PREVENTION MANUAL

405.19 FIRE SPRINKLER COVERAGE UNDER ROOF PROJECTIONS

SUBJECT: NFPA #13, 1996 EDITION, SECTION 4-13.7

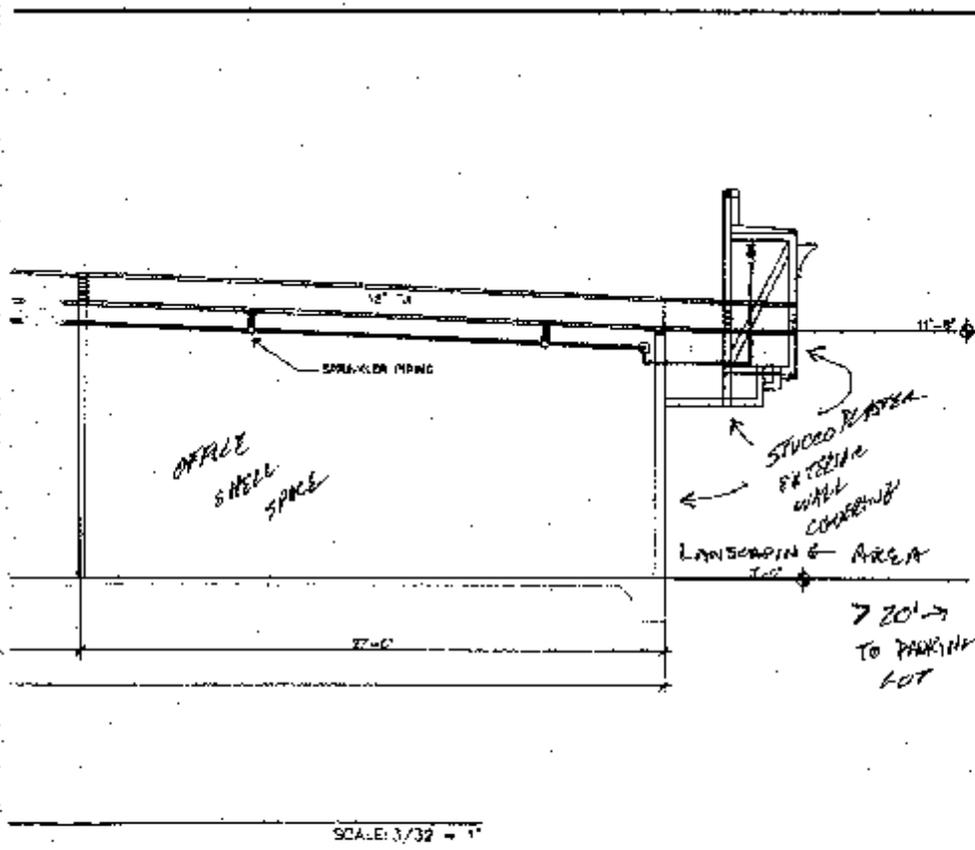
A local sprinkler designer is questioning my interpretation of the above referenced section. Please see the attached drawing for the exterior roof area (mansard) in question. Sprinklers are proposed within the combustible concealed space, but none underneath the 8 foot overhang. This overhang projects over landscaping areas only with no storage space available, and well away from parking areas.

As long as the combustible concealed space is protected, is it the intent of this section to require fire sprinklers under plaster stuccoed projection over landscaped or other unuseable spaces? If so, what is the rationale for the requirement?

Per section 4-13.7, sprinklers would be required under the exterior roof described in your letter if the exterior roof is of combustible construction. No exception is provided, if the concealed space within the exterior combustible roof is protected with sprinklers. If you wish to revise this requirement, please submit a proposal to do so. Proposal forms are located in the back of NFPA codes and standards.
